WEDGWOOD CENTER DEVELOPMENT

Early Design Guidance - 2

SDCI # 3040032-EG

10/28/2024

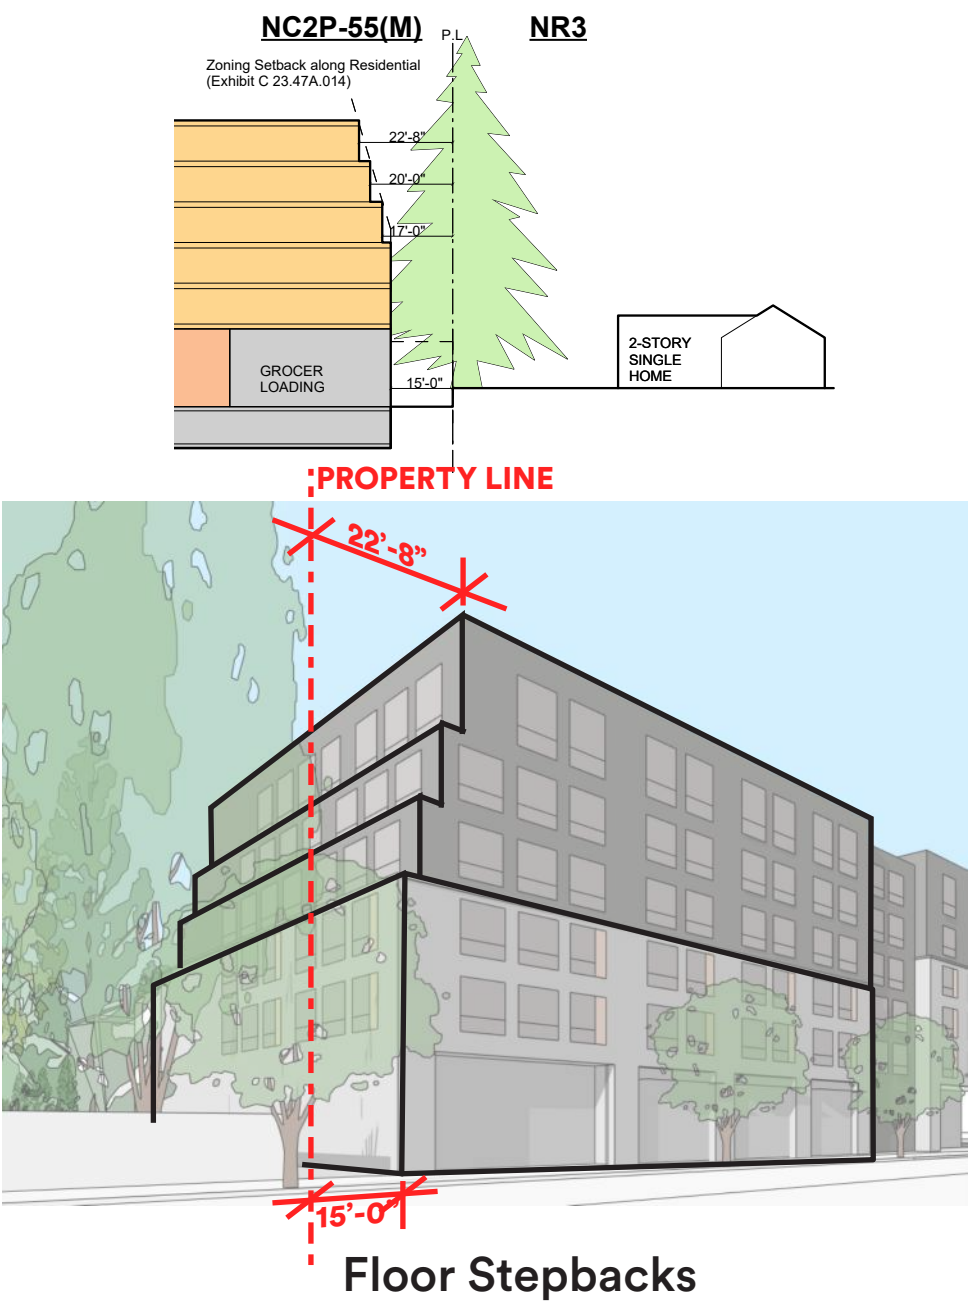
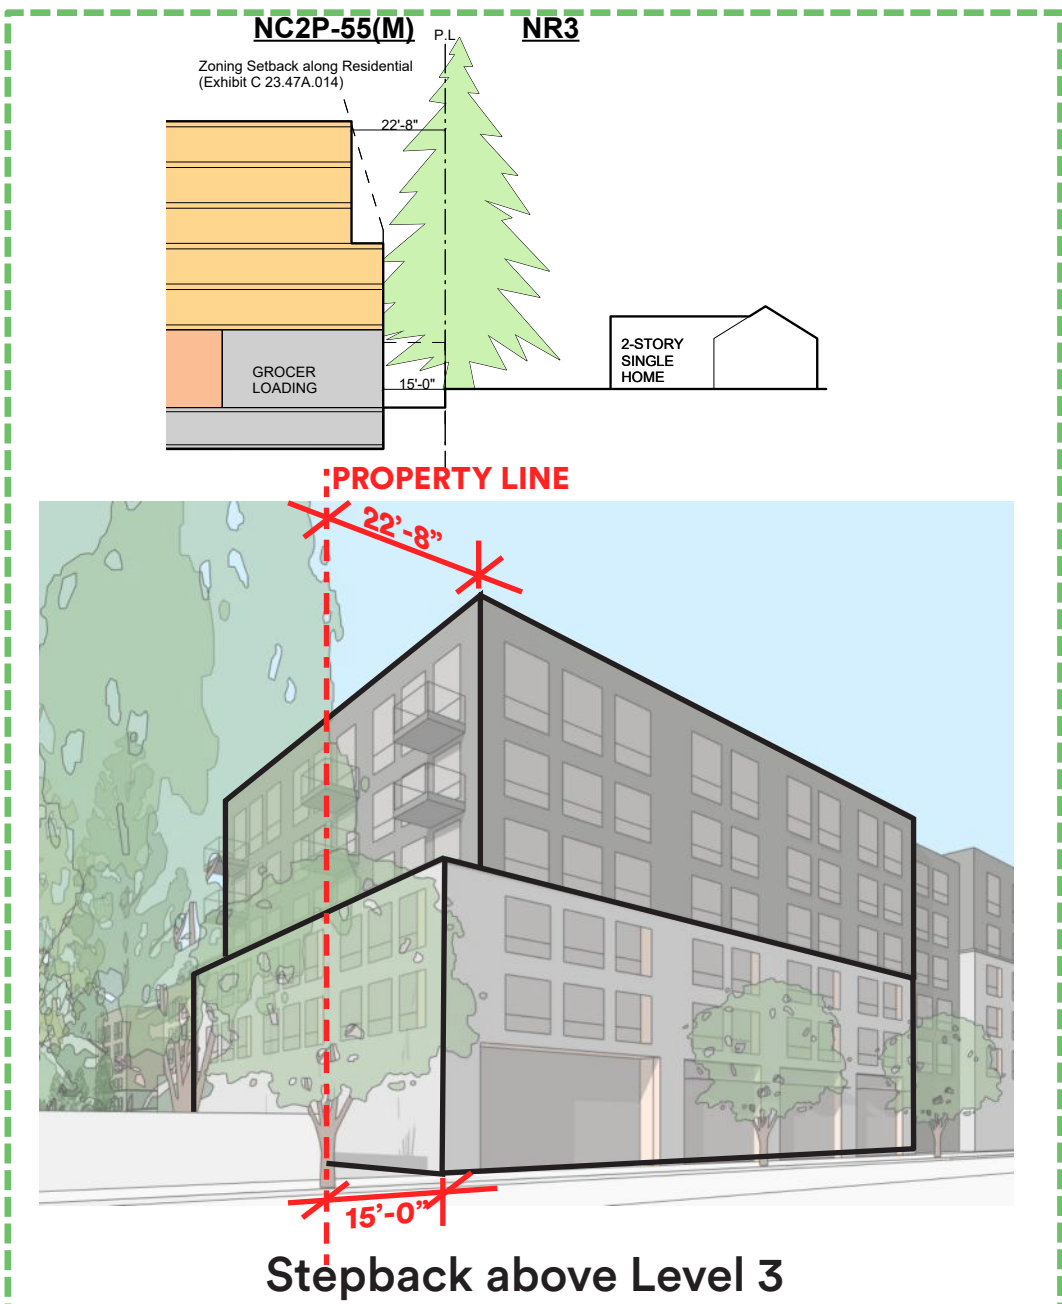
B. **Request for** more study of the massing transition along the north facade to the east facade at the zone transition.

The design team studied several massing alternates along the the NE Corner of the lot. See studies below.

- A proposed step above Level 1 creates an emphasis on the loading volume.
- The loading zone receives the same finishes as the primary building, minimizing its presence (DC1-C-2)

- The proposed massing step matches the angle of the zoning setback along a residential zone
- The loading zone receives the same finishes as the primary building, minimizing its presence (DC1-C-2)

- Preferred**
- The proposed massing step above Level 3 matches the primary building massing and maximizes the setback above as we transition so the adjacent single family residences (CS2-D)
 - The proposed step height and extent connects to the scale of the adjacent neighborhood while working with the existing trees to provide screening and privacy. (CS2-D)
 - The loading zone receives the same finishes as the primary building, minimizing its presence (DC1-C-2)

Loading Berth on 85TH

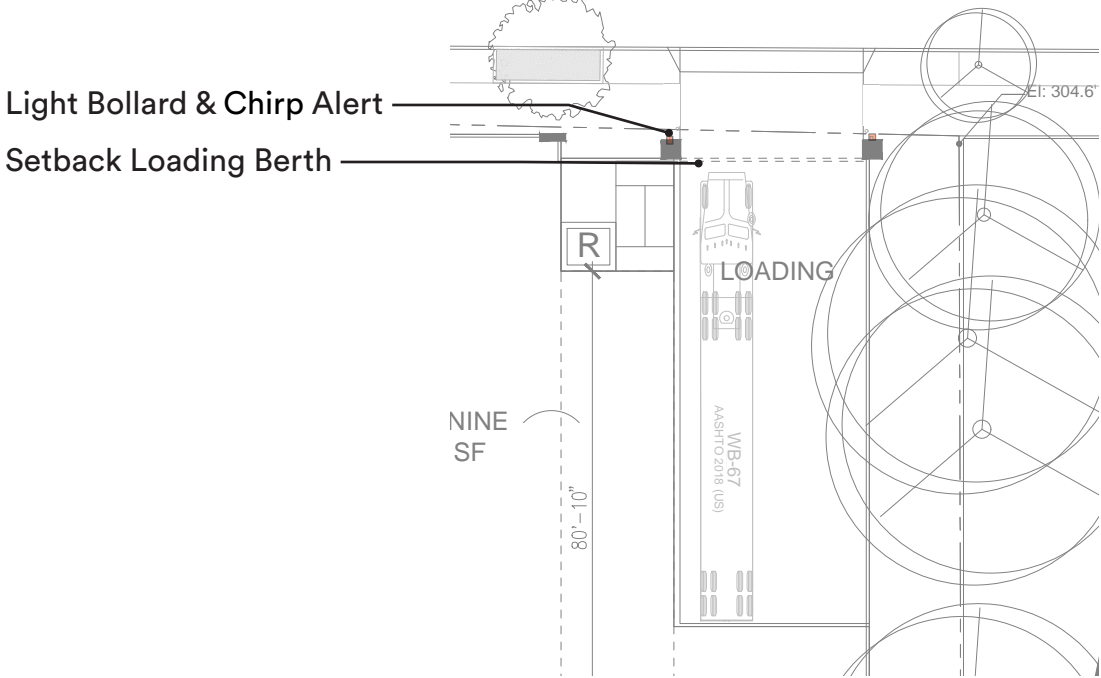
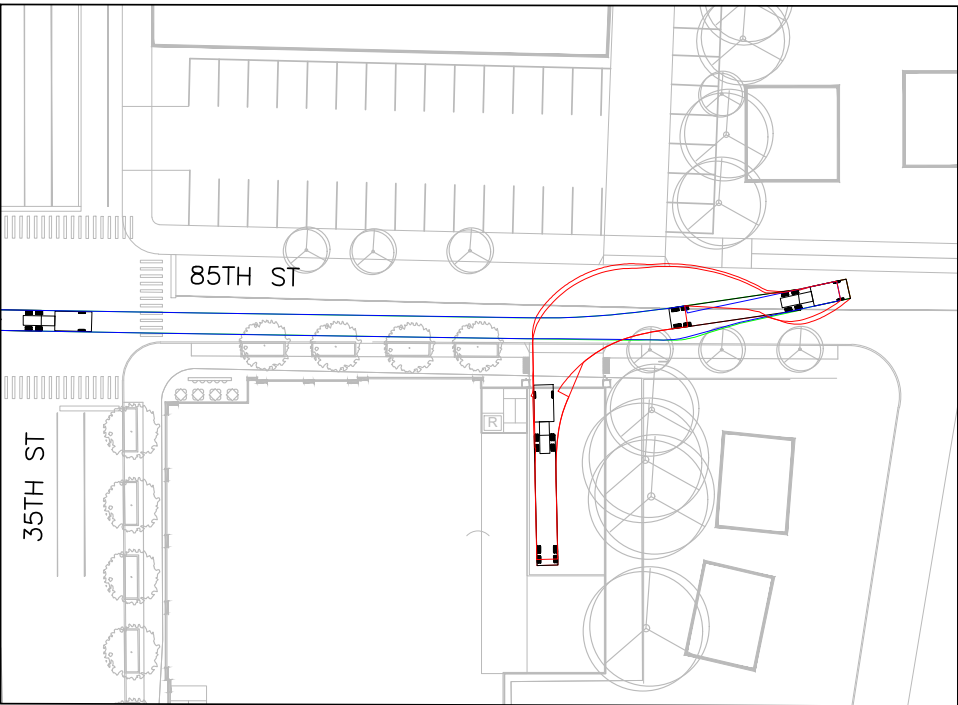
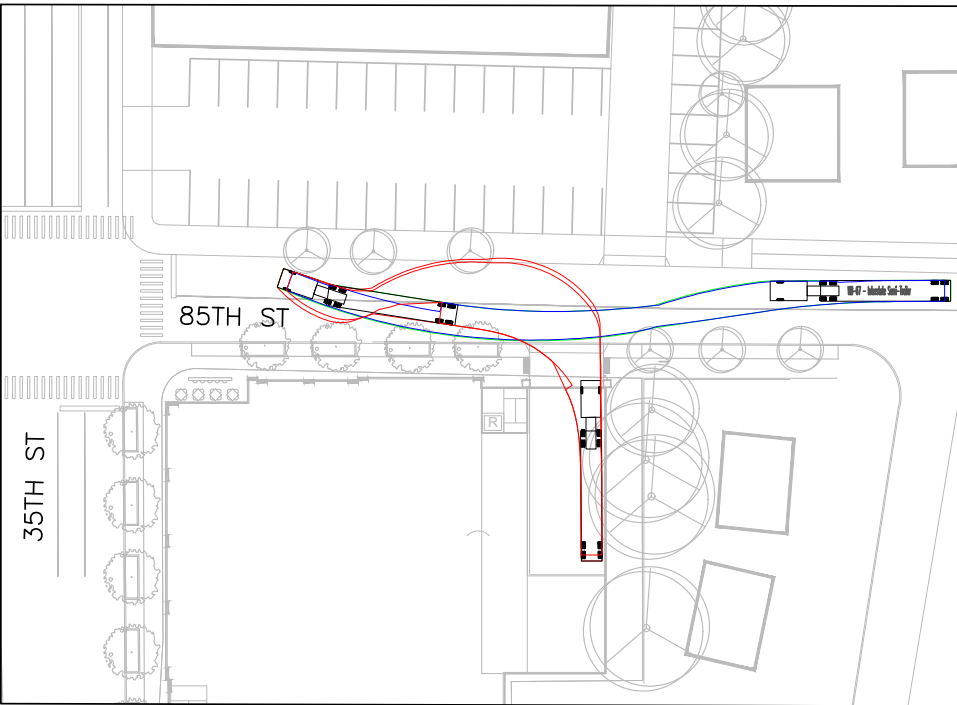
A. **Support** for the proposed loading dock along 85th, but **request** for more study to address questions about pedestrian safety at the sidewalk and vehicle safety at the right of way

The Board generally supported the commercial loading dock along the north property line accessed from NE 85th St but had concerns on how the function may impact both pedestrian safety at the sidewalk and vehicle safety within the right-of-way. The Board requested more thorough studies of truck access strategies to ensure safety in the public realm.

As required by the grocer’s program, the design team is proposing (2) loading berths that can accept up to 70’ long trucks. Turning studies were completed to show trucks could back in from 85th traveling either east or west. We’ve also added additional measures around the dock to ensure this berth is safe for pedestrians. Please see the items listed below:

- Light bollards
- Change scoring of driveway 2’x2’
- Signage
- Loading Dock Management Plan

Proposed Section along east

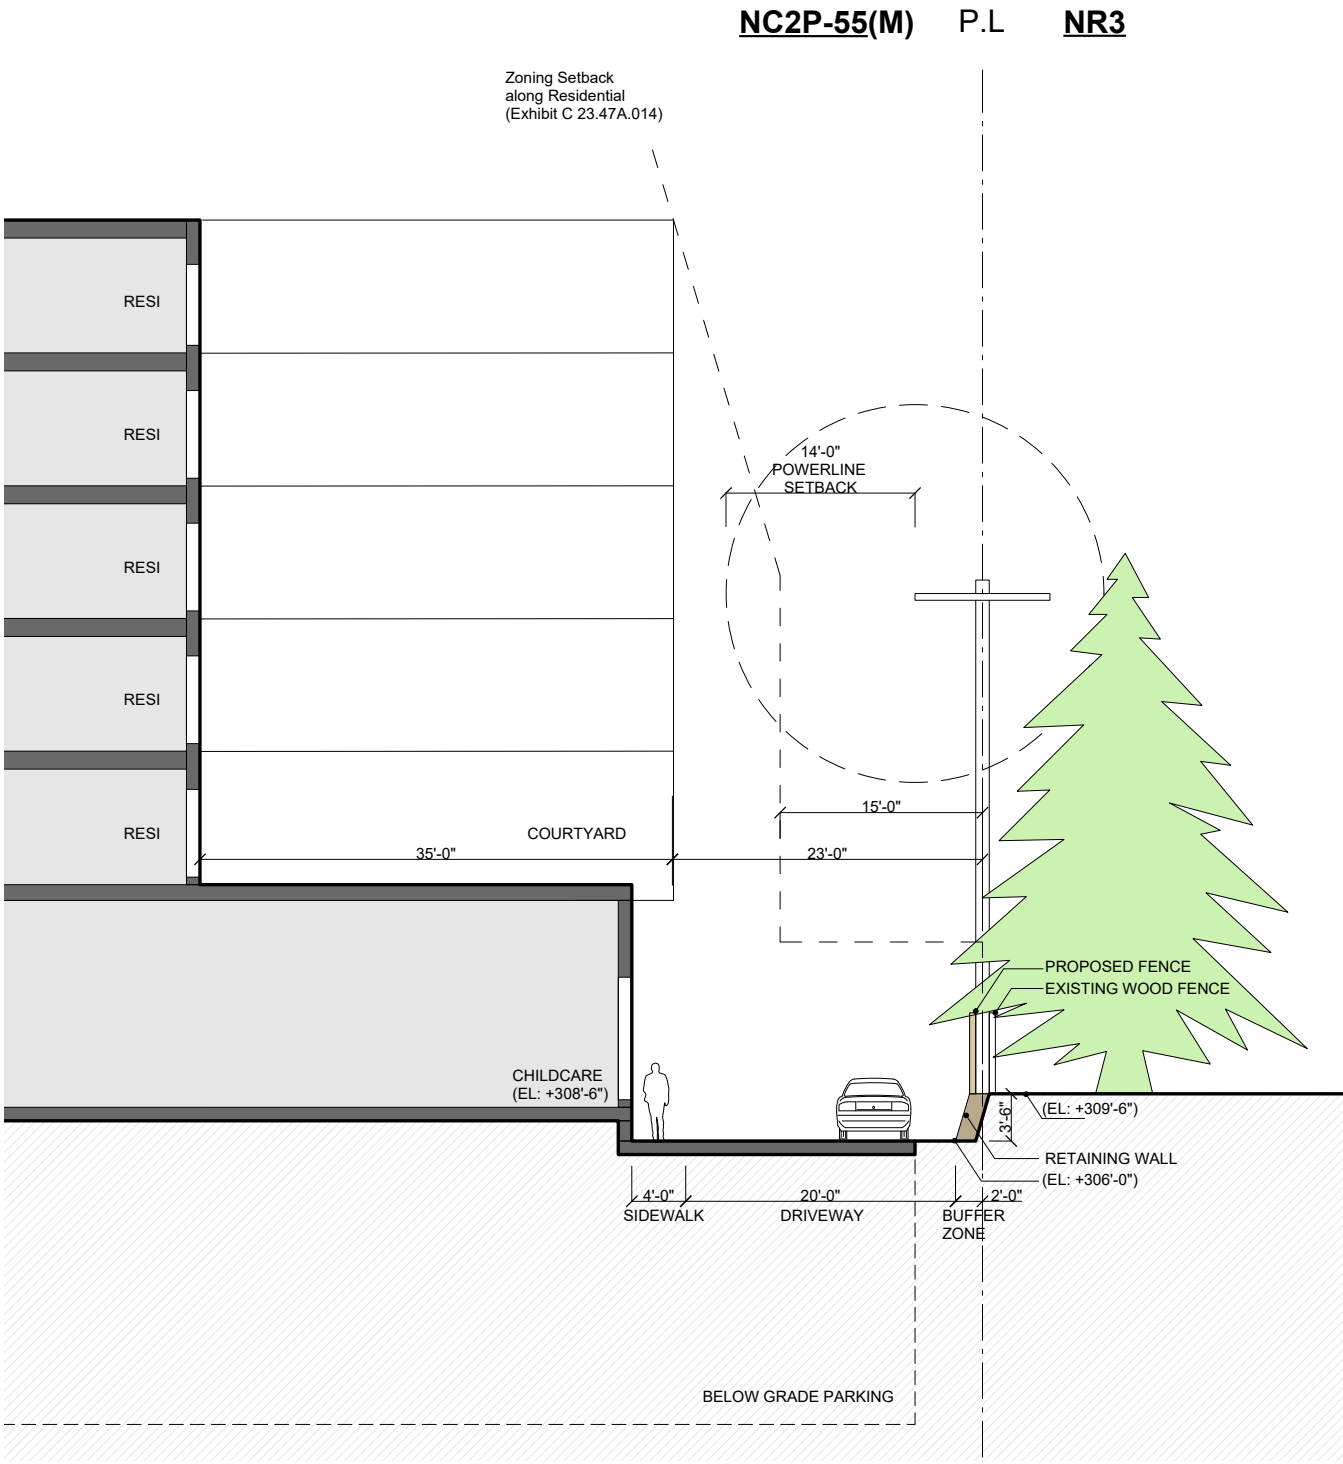
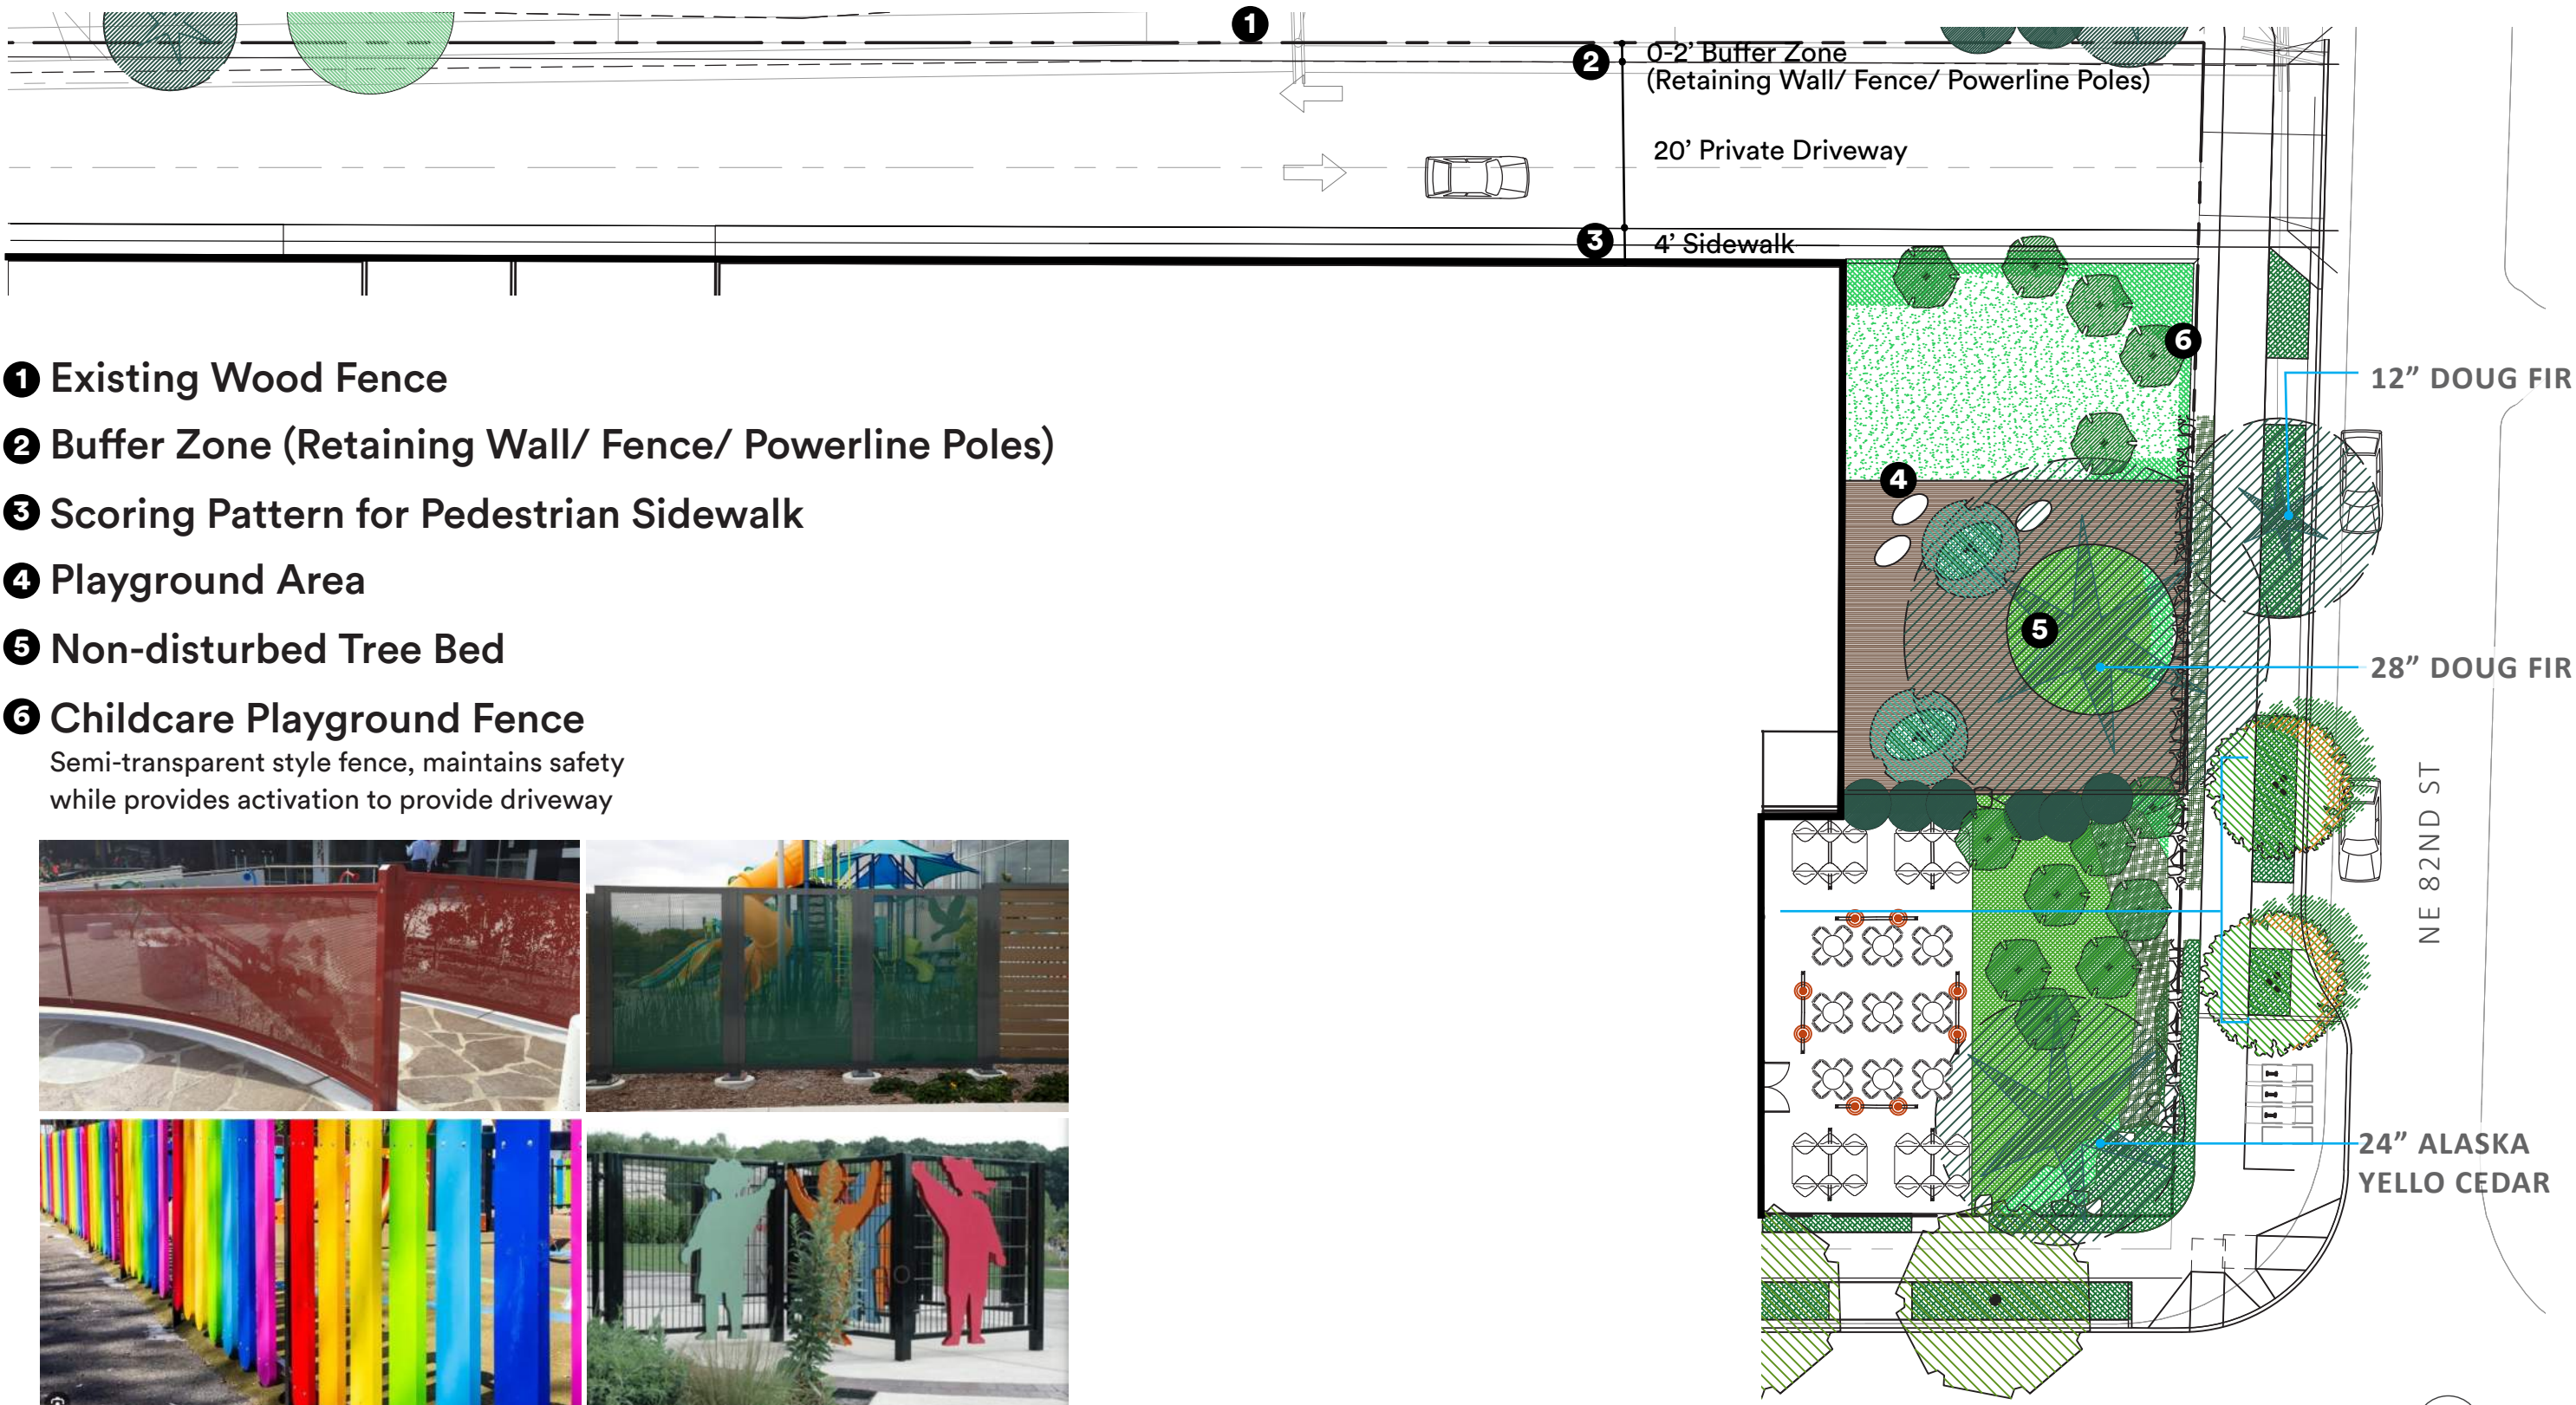
- A. **Support** for private driveway along the east property line to support pedestrian and bike traffic
- C. **Request** for more information about the use of private drive and buffer to the adjacent lower density neighborhoods

The Board generally supported the private drive that could also support pedestrian and bicycle access from NE 82nd St to the center of the development. They had concerns about the design of the private drive along the east property line (accessed at the southeast corner of the site) and potential impacts to the adjacent lower density neighborhood. The Board requested studies to show how the design of the drive, including plantings, fencing, grade differential, etc., can help in buffering and screening vehicle access

The minor grade change, in combination with visual planting & fencing screening, will retain privacy for the adjacent properties (CS2-D-5) and the proposed building set back approximately 20’ from the property line adjacent to existing neighbors.

- 1 Existing Wood Fence
 - 2 Buffer Zone (Retaining Wall/ Fence/ Powerline Poles)
 - 3 Scoring Pattern for Pedestrian Sidewalk
 - 4 Playground Area
 - 5 Non-disturbed Tree Bed
 - 6 Childcare Playground Fence
- Semi-transparent style fence, maintains safety while provides activation to provide driveway
